# Site Accessibility Evaluation

### **Bear Creek Nature Center**

**Accessibility Evaluation**

***Inspection Date: 05/06/2020***

### Finding: 1

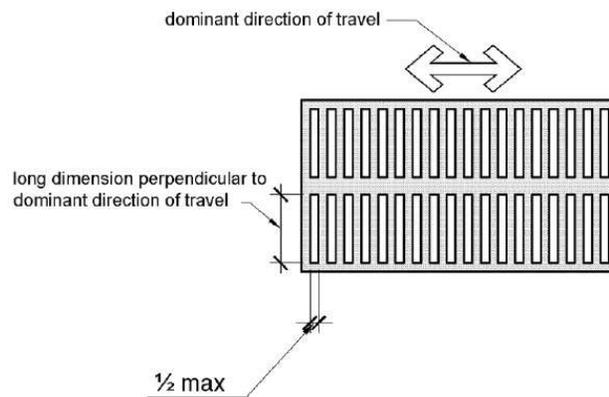
The concrete expansion joint is spaced greater than 1/2 inch.

Openings in floor or ground surfaces shall not allow passage of a sphere more than 1/2 inch diameter. Elongated openings shall be placed so that the long dimension is perpendicular to the dominant direction of travel.

Citation:	As Built:	Budgeting Range:
2010 ADAS Section: 302.3	Expansion joint 2 inches in width	\$1,500 - \$4,500.00

Crack fill expansion joints to ensure an opening no more than 1/2 inch in diameter.

### **Finding: 2**

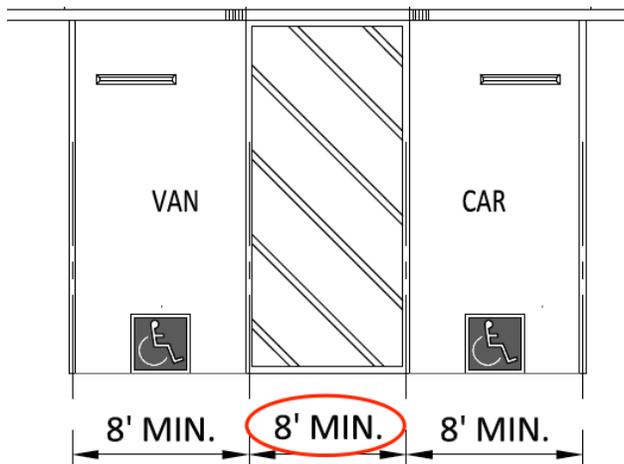
The access aisle is not a minimum 8 feet to the centerline of the stripe.

The accessible parking stall access aisle must be a minimum of 8 feet wide measured from centerline to centerline.

7ft 2 inches in width

Re-stripe access aisle and ensure a minimum width of 8 feet measured to the center of the paint stripe.

### **Finding: 3**

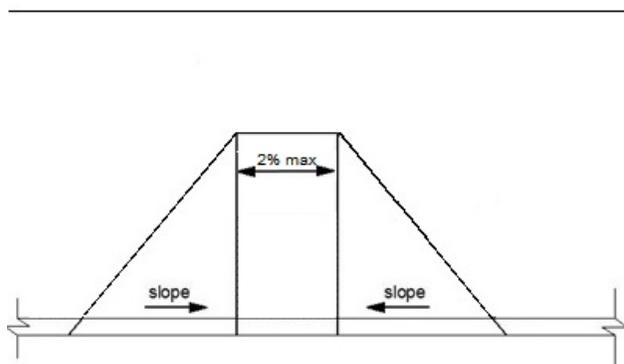
The curb ramp on the accessible route contains cross slopes greater than 2%.

Surface cross slopes shall not exceed one unit vertical in 48 units horizontal (2-percent slope).

Curb ramp has 2.71%  
cross slope

During re-construction/remodel, replace existing pedestrian ramp and construct a parallel curb ramp to meet current ADA standards.

### **Finding: 4**

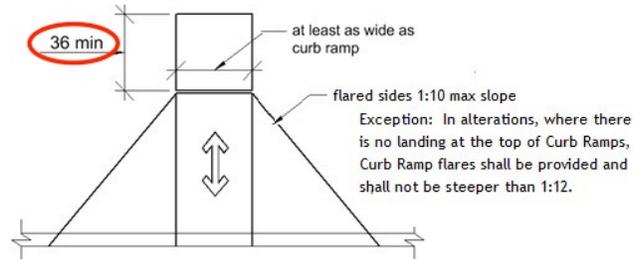
The top of the curb ramp does not have a level landing.

A level landing 36 inches in deep shall be provided at the upper end of each curb ramp over its full width to permit safe egress from the ramp surface. The landing clear width shall be at least as wide as the Curb Ramp, excluding flared sides, leading to the landing.

No level landing exists  
on top of curb ramp

During re-construction/remodel, replace existing pedestrian ramp and construct a parallel curb ramp to meet current ADA standards.

### **Finding: 5**

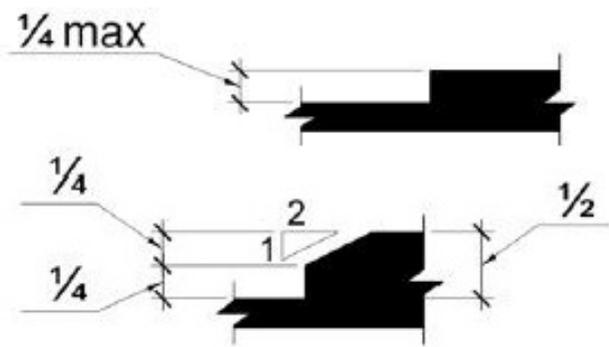
The walkway contains abrupt vertical edges and/or variations over a 1/4 inch.

1/4 inch is the maximum vertical rise. Changes in level between 1/4 inch and 1/2 inch must be beveled at 1:2 or less.

Path of travel contains a couple of abrupt vertical changes greater than 1/4 inch

Shave abrupt vertical changes along the walkway/path of travel.

### **Finding: 7**

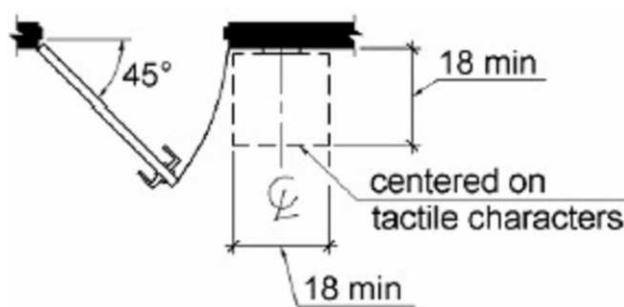
Clear floor space is not provide at the tactile door sign.

Signs containing tactile Characters shall be located so that a clear floor space of 18 inches minimum by 18 inches minimum, centered on the tactile Characters, is provided beyond the arc of any door swing between the closed position and 45 degree open position.

6.5 inches to  
centerline of sign

Reposition restroom sign to 9 inches minimum centerline of tactile sign measured from the edge of door frame opening.

### **Finding: 8**

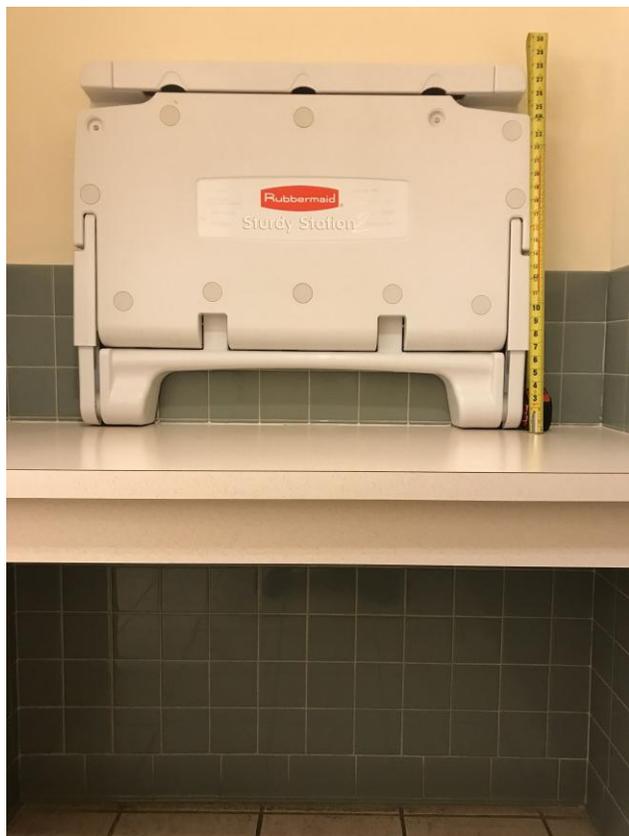
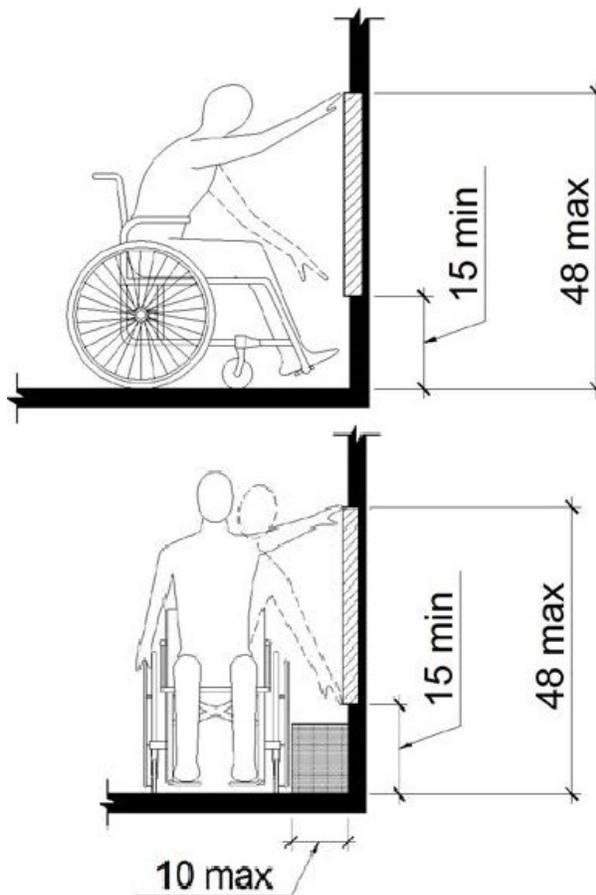
The baby changing table operating mechanism is outside reach range.

The maximum high reach allowed is 48 inches.

58 inches above finished floor to operable part

If possible, relocate baby changing station to another section/wall and ensure it meets ADA standards. If baby changing station cannot be relocated, remove and use existing table/counter as baby changing station. Existing table/counter meets ADA compliance for knee, toe, height and forward approach clearance.

### **Finding: 10**

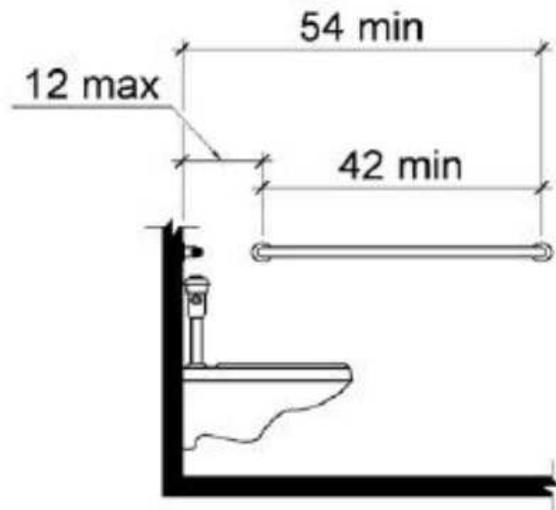
The side grab bar is located greater than 12 inches from the rear wall.

The side grab bar must extend at least 54 inches minimum beyond the rear wall and start a maximum of 12 inches from the rear wall. A 42 inch grab bar installed the maximum distance from the rear wall (12 inches) will leave the leading end 54 inches from the rear wall. Grab bars shall be installed in a horizontal position, 33 inches minimum and 36 inches maximum above the finish floor measured to the top of the gripping surface.

11.25 inches from rear wall

Adjust side grab bar not to exceed 12 inches from rear wall measured to the centerline of the grab bar. Side grab bar must be 42 inches minimum in length and extend at least 54 inches minimum beyond the rear wall measured to the centerline of the grab bar.

### **Finding: 11**

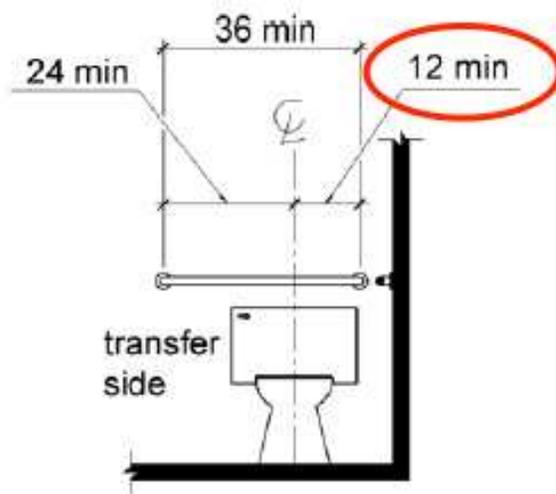
The rear grab bar does not extend adequately past the centerline of the toilet on the wall side.

The rear grab bar must be a minimum of 36 inches long and extend from the centerline of the toilet 12 inches minimum on one side and 24 inches minimum on the other side.

7 inches past  
centerline of toilet to  
wall side

Re-position rear grab bar to extend from the centerline of the toilet 12 inches minimum to the wall side and 24 inches minimum to the transfer/open side.

### **Finding: 12**

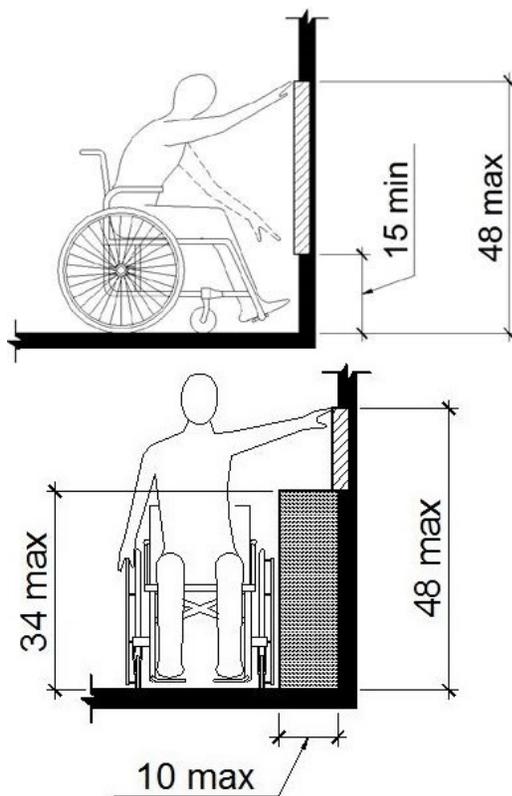
The coat hook is installed greater than 48 inches above the finished floor.

Where a forward reach is unobstructed, the high forward reach shall be 48 inches maximum above the finished floor.

Coat hook 66.25  
inches above finished  
floor

Lower coat hook 19 inches minimum or install another coat hook not to exceed a maximum height of 48 inches above finished floor.

### **Finding: 13**

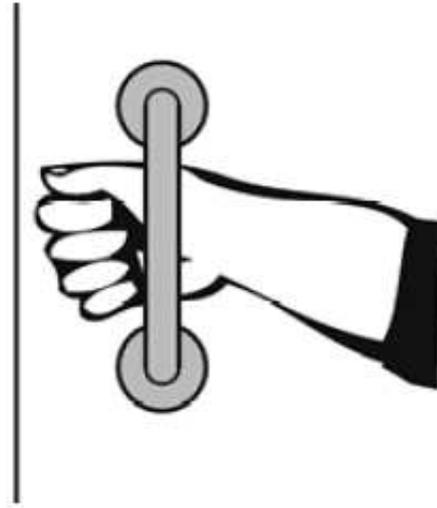
The water closet compartment door is missing a loop handle.

Water closet compartments must be equipped with a door that has a loop or U-shaped handle on both sides of the door immediately below the latch. The latch must be flip-over style, sliding or other hardware not requiring the user to grasp or twist.

Compartment door  
missing loop handles

Install loop or U-shape handles on the inside and outside of the compartment door. Between 36 - 40 inches preferred.

### **Finding: 14**

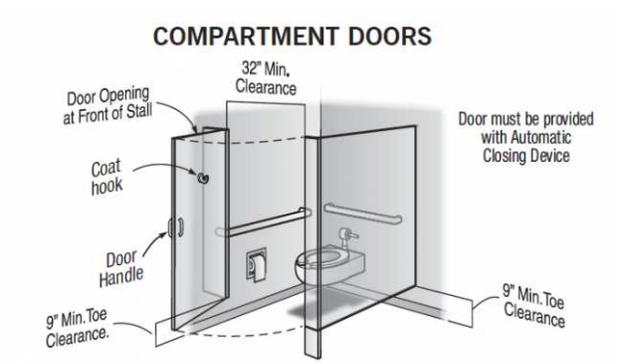
**The compartment door is not self closing.**

**The water closet compartment shall be equipped with a door that has an automatic-closing device.**

Compartment door not self-closing

Adjust or install automatic closing hinges.

### **Finding: 15**

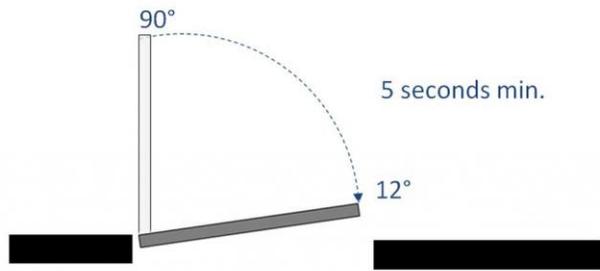
The door is equipped with a door closer and returns to a closed position too quickly.

Door closers and gate closers shall be adjusted so that from an open position of 90 degrees, the time required to move the door to a position of 12 degrees from the latch is 5 seconds minimum.

4.96 seconds to closed position

Adjust door closer to allow a minimum of 5 seconds to move from the open position at 90 degrees to 12 degrees from the latch/locking mechanism.

### **Finding: 17**

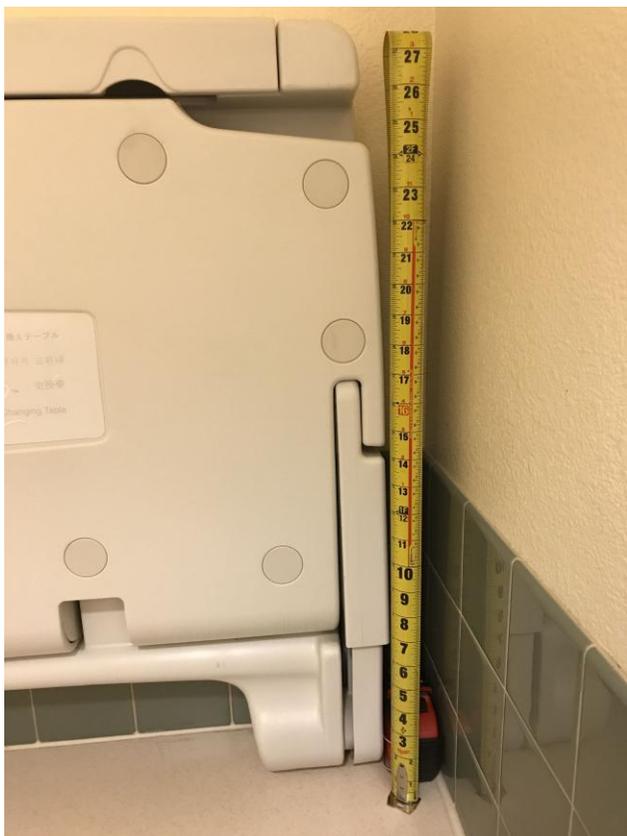
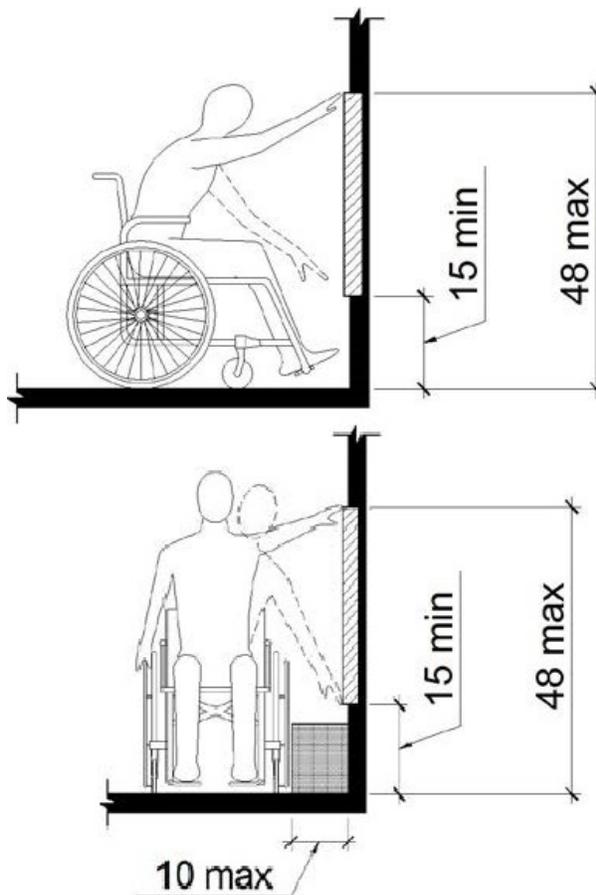
The baby changing table operating mechanism is outside reach range.

The maximum high reach allowed is 48 inches.

59 inches above  
finished floor to  
operable part

If possible, relocate baby changing station to another section/wall and ensure it meets ADA standards. If baby changing station cannot be relocated, remove and use existing table/counter as baby changing station. Existing table/counter meets ADA compliance for knee, toe, height and forward approach clearance.

### **Finding: 18**

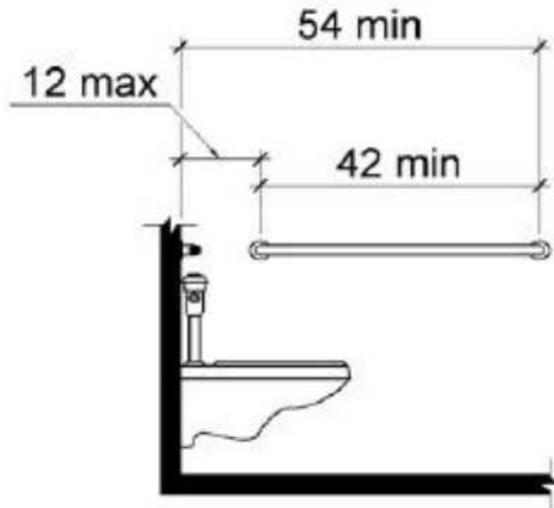
The side grab bar is located greater than 12 inches from the rear wall.

The side grab bar must extend at least 54 inches minimum beyond the rear wall and start a maximum of 12 inches from the rear wall. A 42 inch grab bar installed the maximum distance from the rear wall (12 inches) will leave the leading end 54 inches from the rear wall. Grab bars shall be installed in a horizontal position, 33 inches minimum and 36 inches maximum above the finish floor measured to the top of the gripping surface.

11.25 inches from rear wall

Adjust side grab bar not to exceed 12 inches from rear wall measured to the centerline of the grab bar. Side grab bar must be 42 inches minimum in length and extend at least 54 inches minimum beyond the rear wall measured to the centerline of the grab bar.

### **Finding: 19**

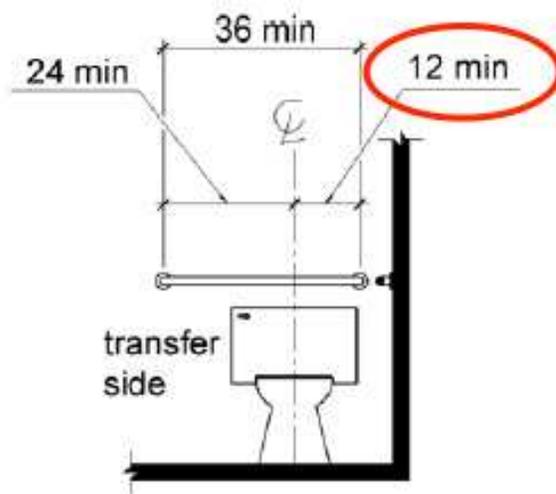
The rear grab bar does not extend adequately past the centerline of the toilet on the wall side.

The rear grab bar must be a minimum of 36 inches long and extend from the centerline of the toilet 12 inches minimum on one side and 24 inches minimum on the other side.

7 inches past  
centerline of toilet to  
wall side

Re-position rear grab bar to extend from the centerline of the toilet 12 inches minimum to the wall side and 24 inches minimum to the transfer/open side.

### **Finding: 20**

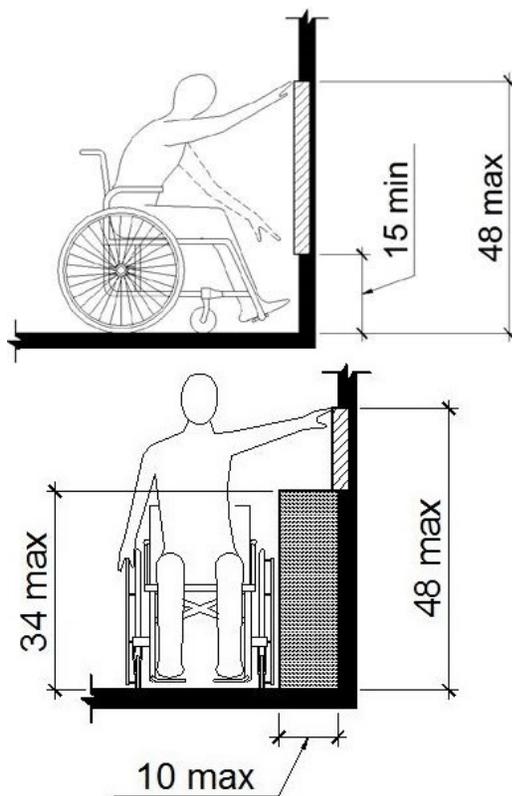
The coat hook is installed greater than 48 inches above the finished floor.

Where a forward reach is unobstructed, the high forward reach shall be 48 inches maximum above the finished floor.

Coat hook 66 inches  
above finished floor

### **Finding: 21**

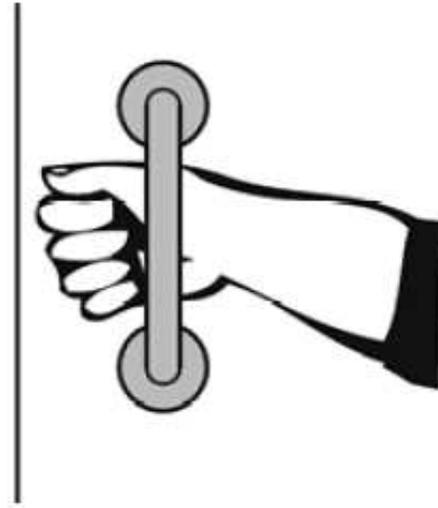
The water closet compartment door is missing a loop handle.

Water closet compartments must be equipped with a door that has a loop or U-shaped handle on both sides of the door immediately below the latch. The latch must be flip-over style, sliding or other hardware not requiring the user to grasp or twist.

Compartment door  
missing loop handles

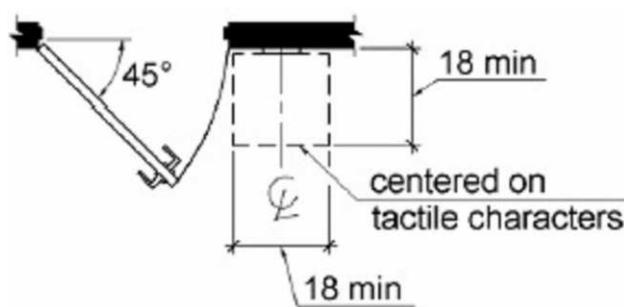
Clear floor space is not provide at the tactile door sign.

Relocate sign to adjacent wall or add another restroom sign on adjacent wall and leave existing sign in place.
